# Addendum No. Two

RFP No: FY24-805-45 A

Airport Terminal Building Improvements AWIP : BHS-TC2/TC4 : A-Wing Offices

This Addendum # 2 to Request for Bids for Airport Terminal Building Improvements AWIP : BHS-TC2/TC4 : A-Wing Offices contains the following responses to bidder inquiries and clarifications or changes to the Bid Documents:

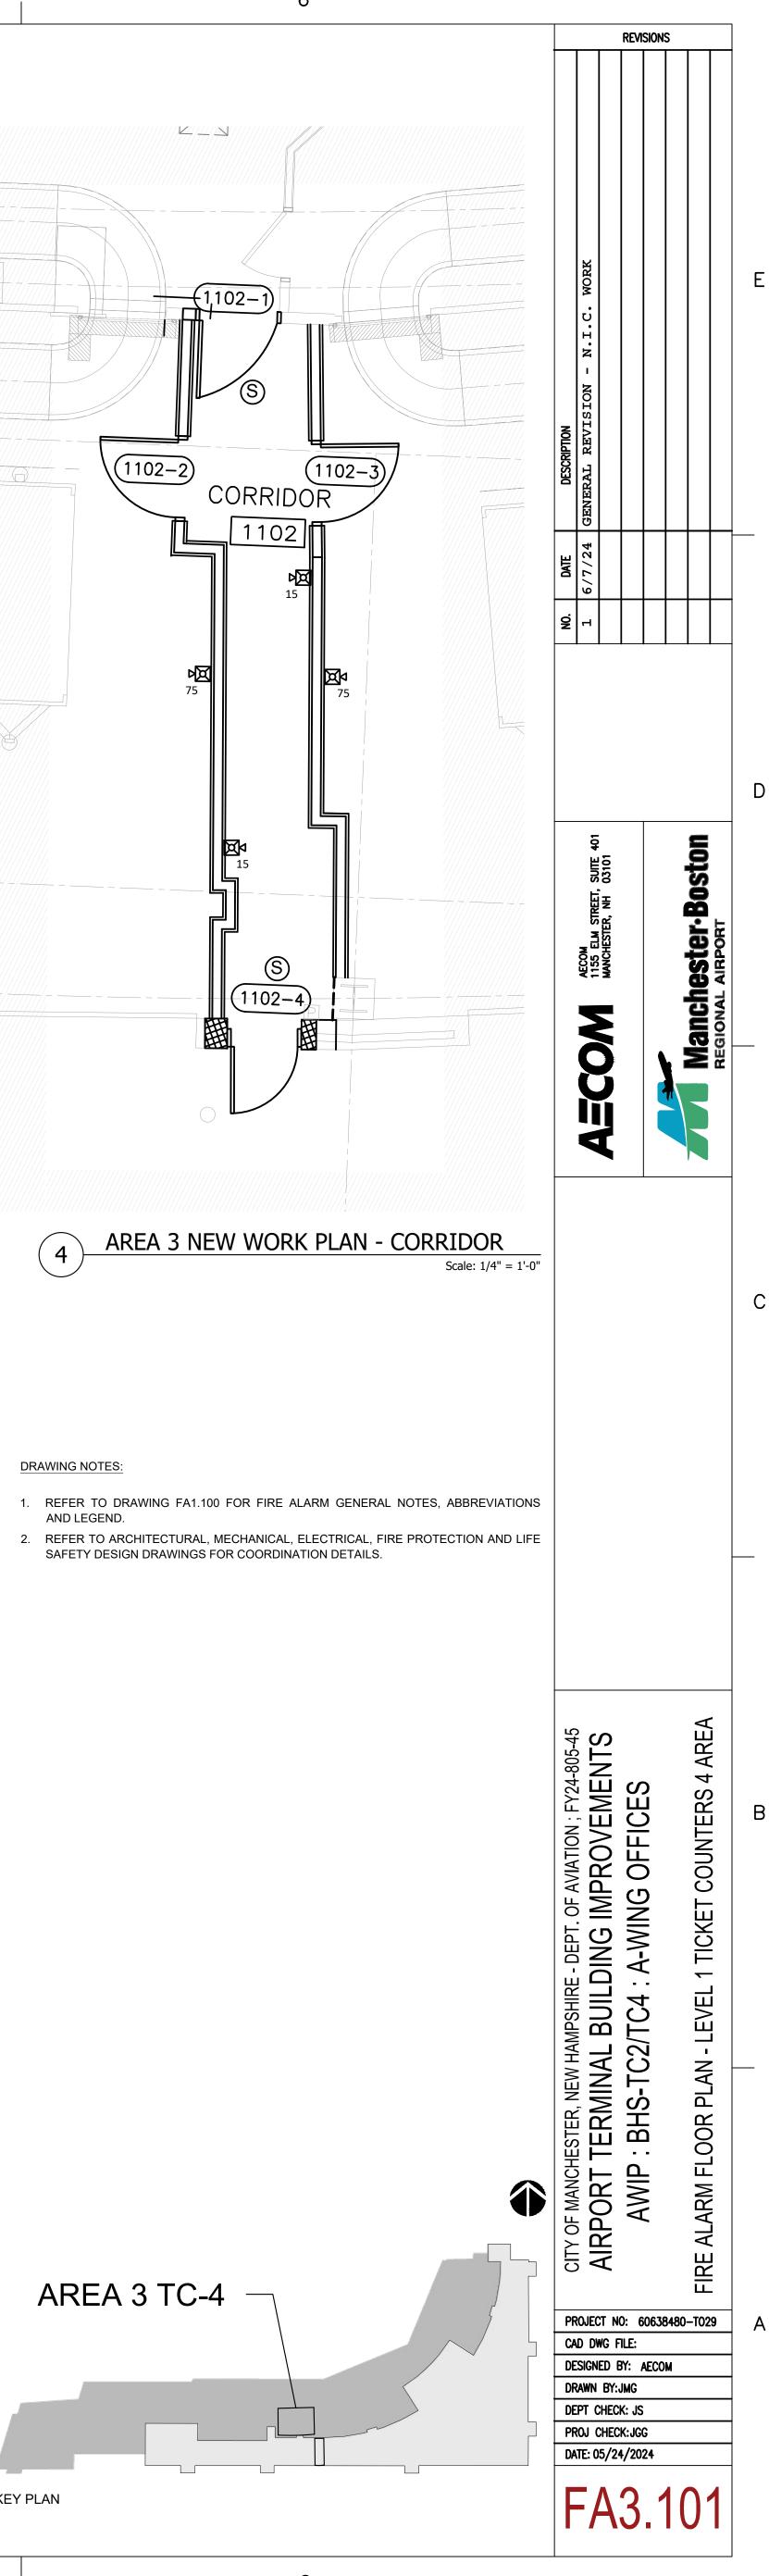
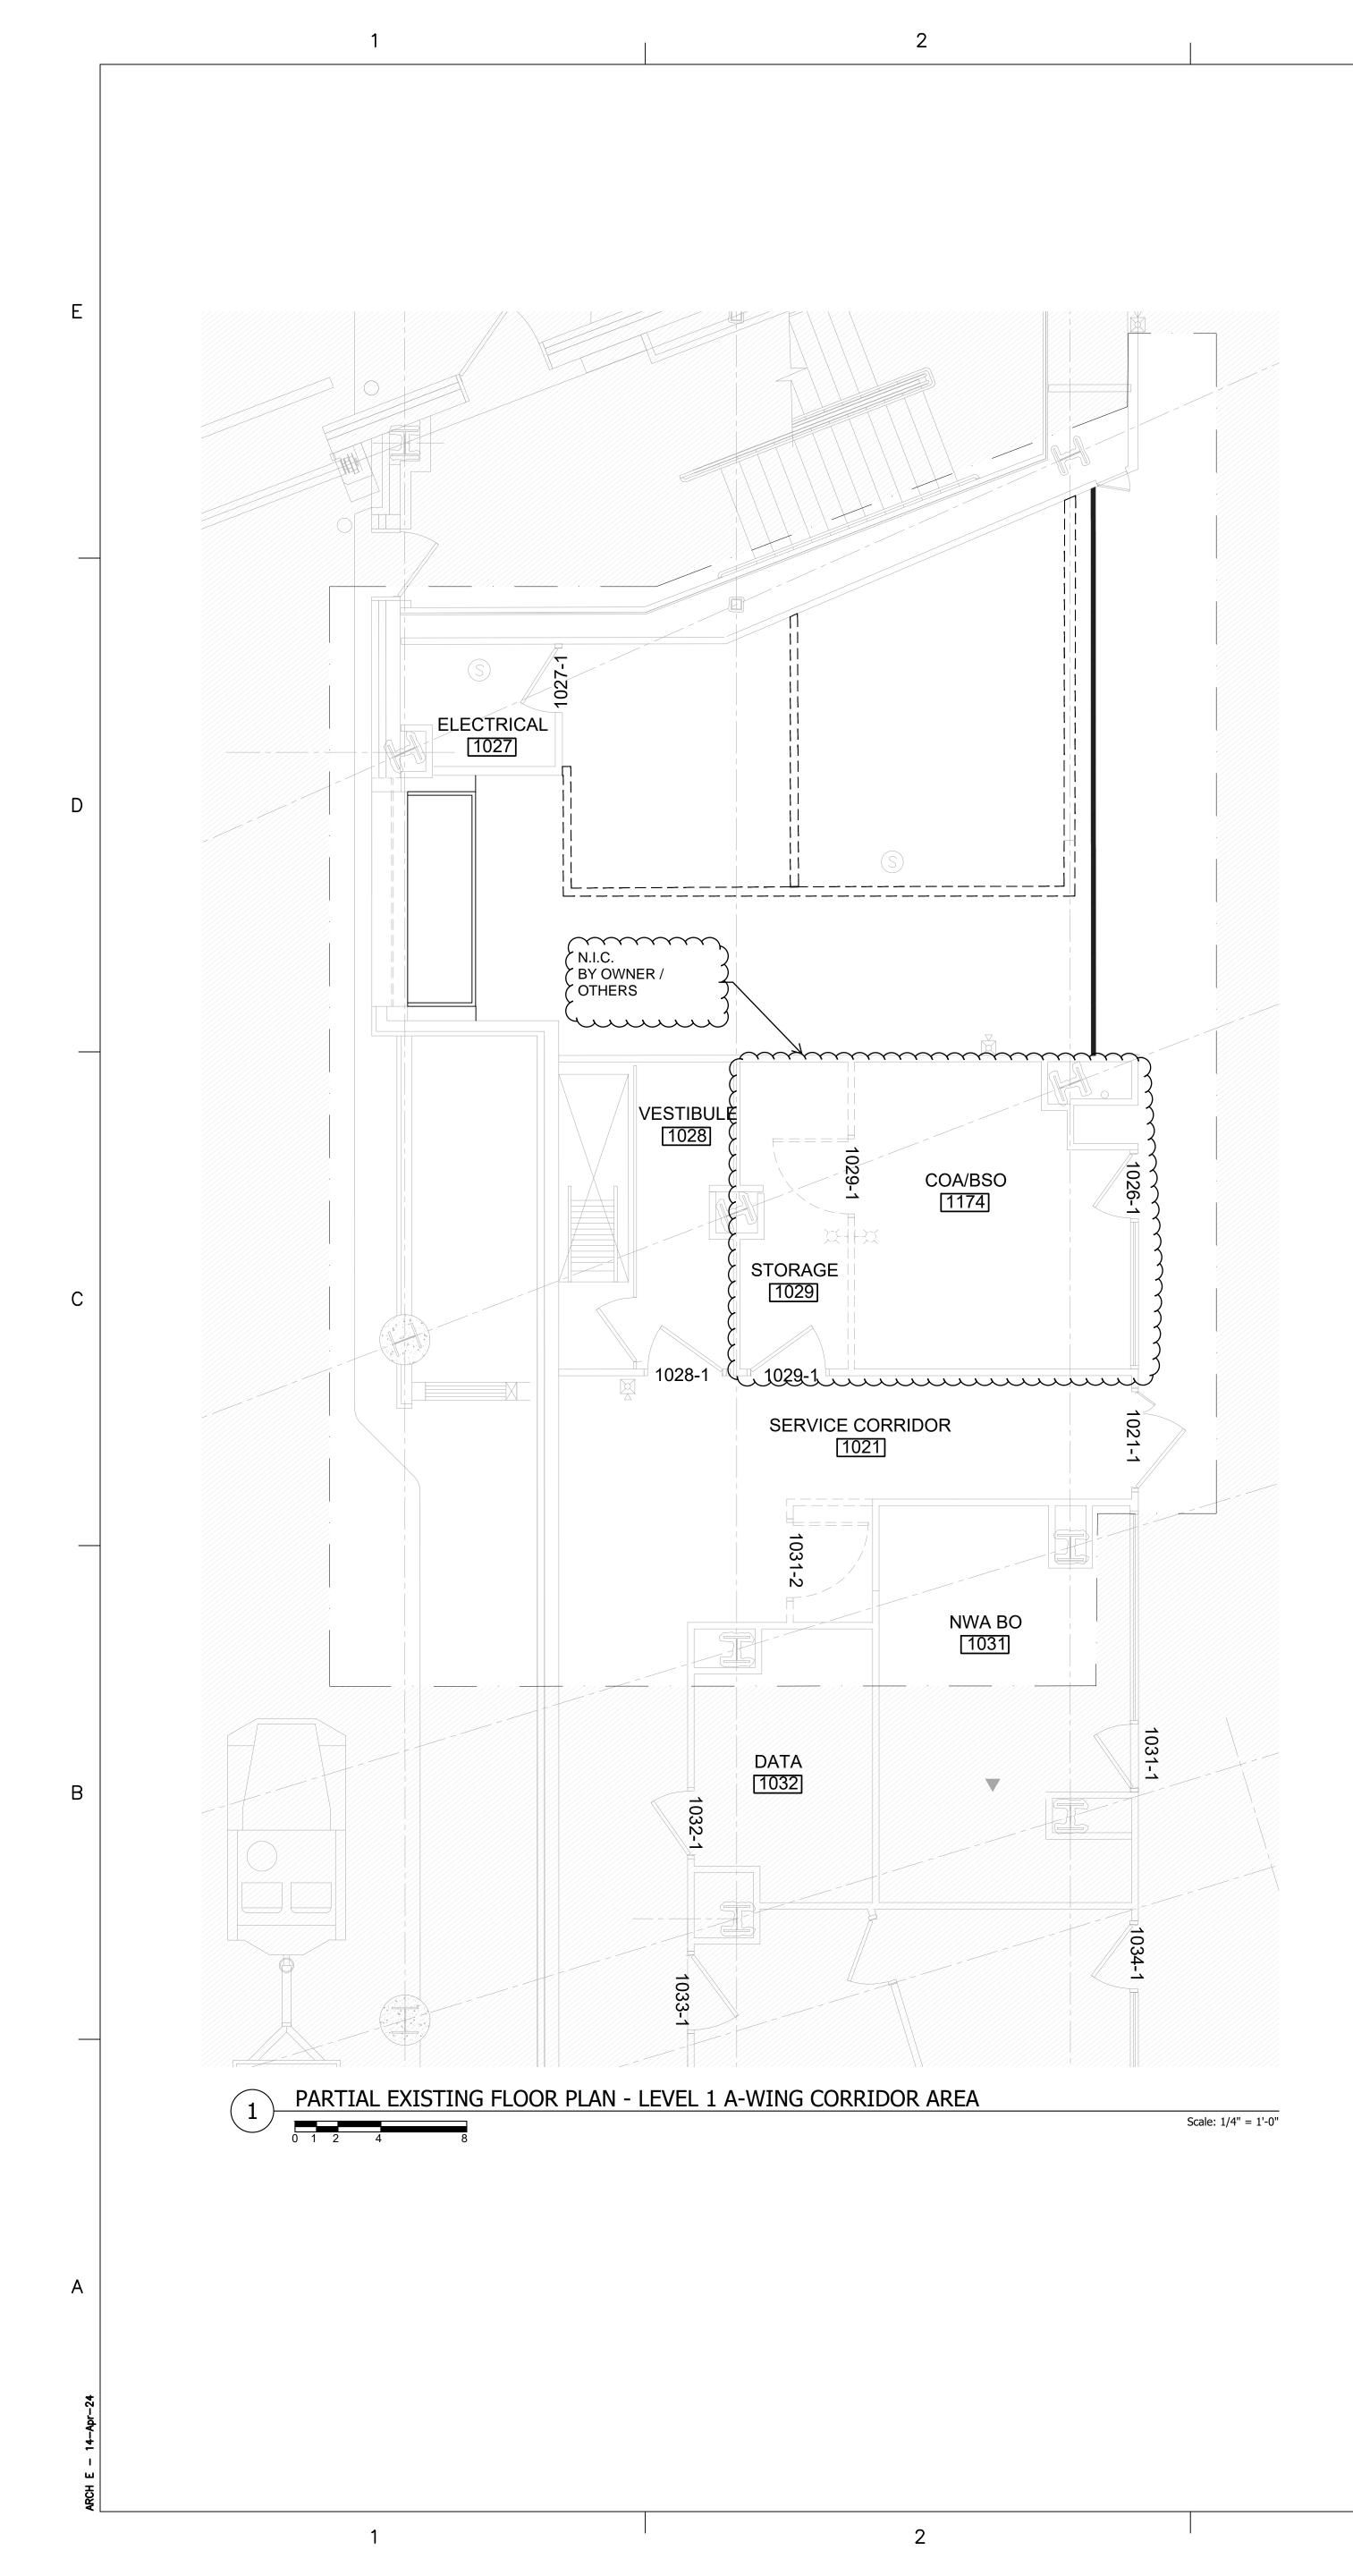
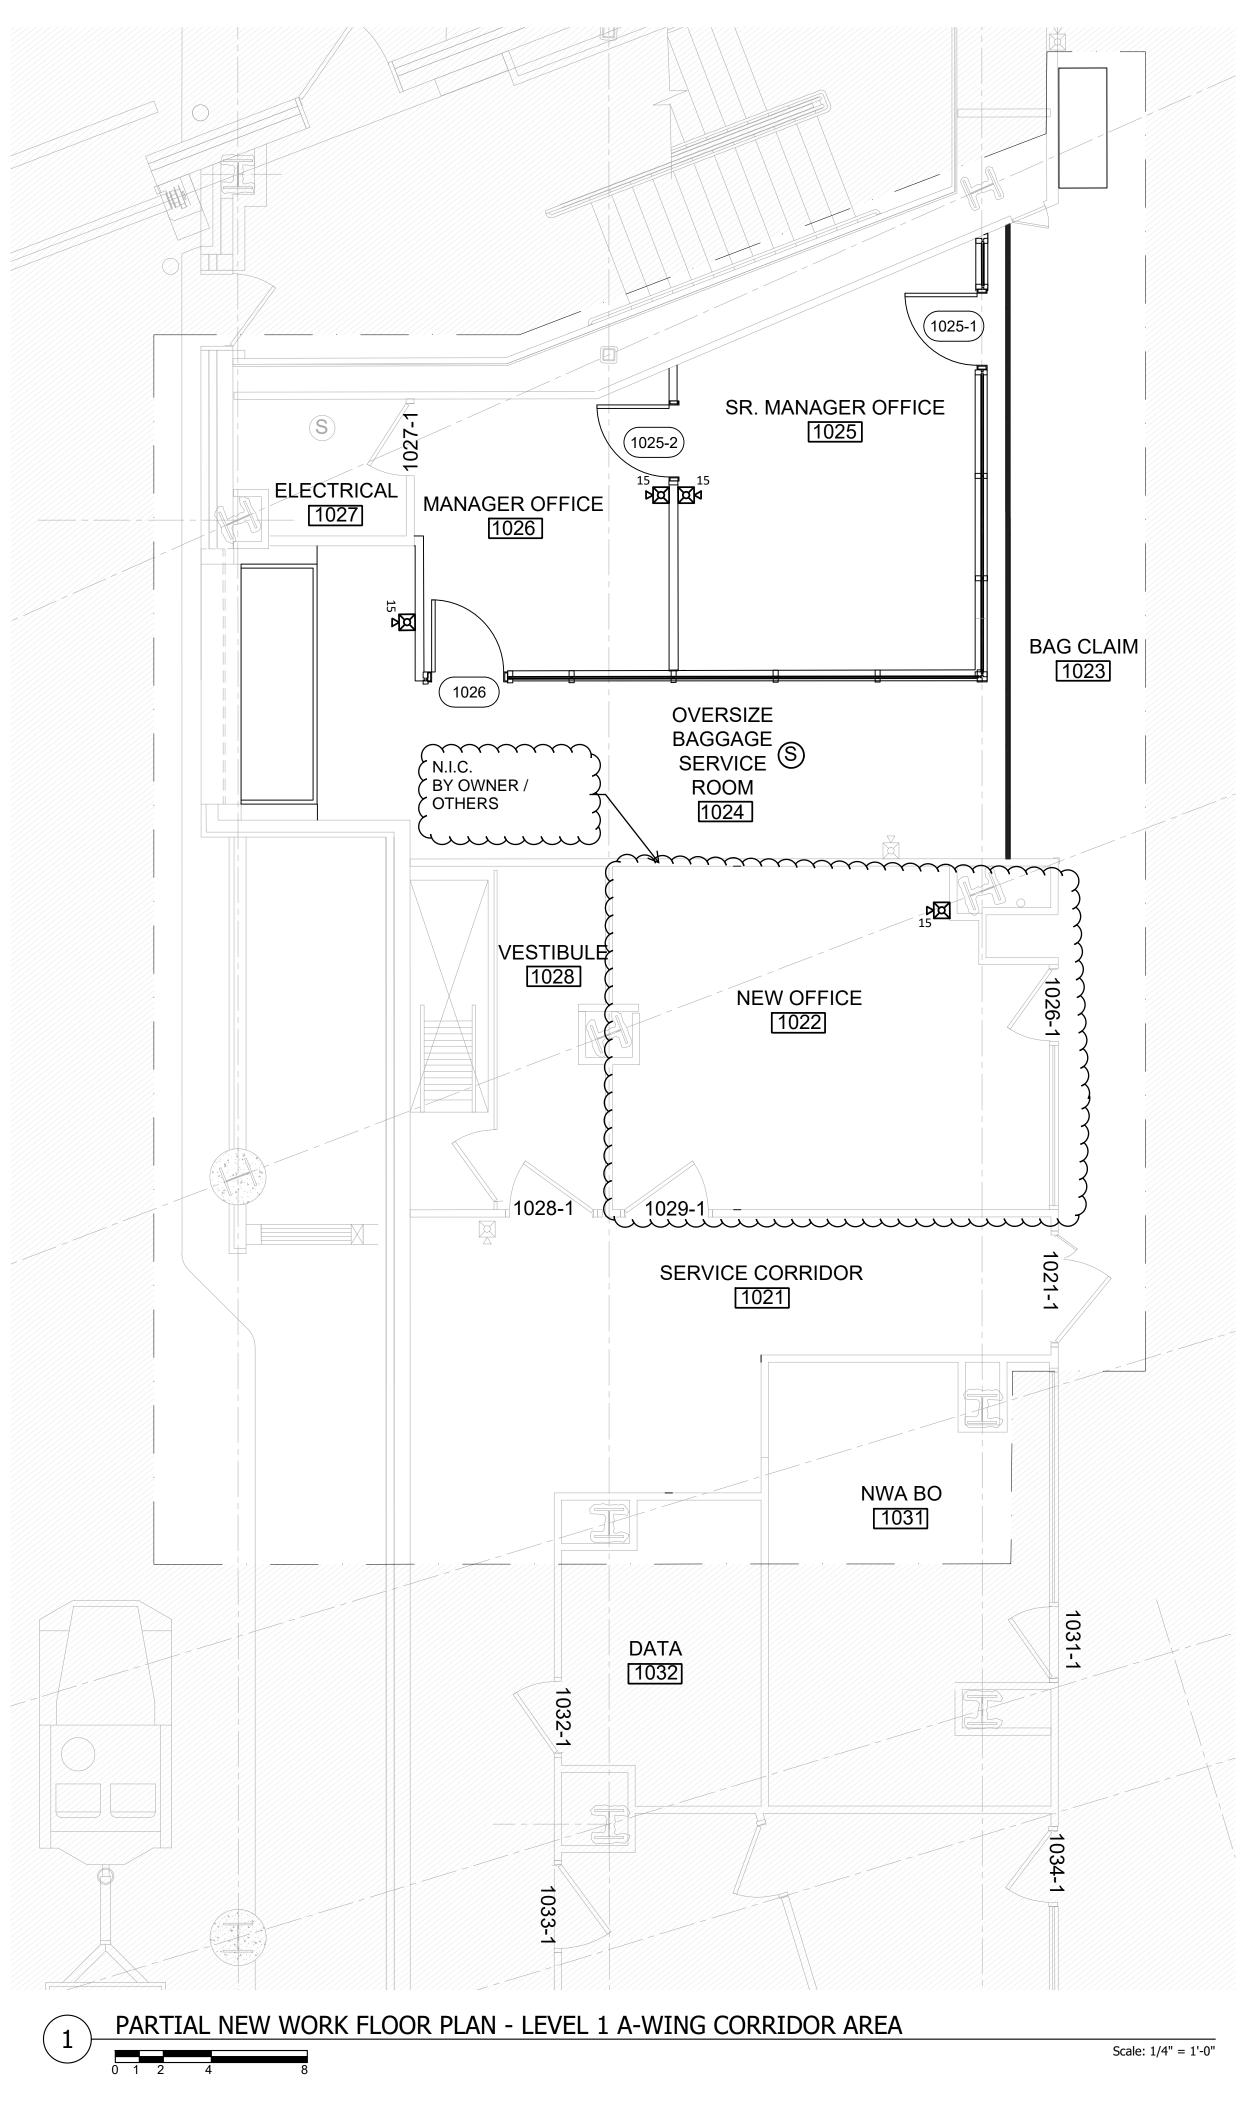
- 1. PROVIDE CONTROL MODULE TO UNLOCK DELAYED EGRESS DOOR AT THIS LOCATION. PROVIDE 24V POWER PER MANUFACTURER REQUIREMENTS.
- 2. PROVIDE CONTROL MODULE TO CONTROL FIRE ALARM RELEASE OF MAGNETIC DOOR HOLD-OPEN UPON FIRE ALARM ACTUATION. COORDINATE INSTALLATION OF CONTROL MODULE WITH ELECTRICAL/HOLD-OPEN INSTALLER. PROVIDE 24V POWER PER MANUFACTURER REQUIREMENTS.
- 3. WALL SHOWN TO BE PROVIDED IN FUTURE CONTRACT. 4. ELECTROMAGNETIC DOOR HOLD OPEN (PROVIDED BY OWNER).
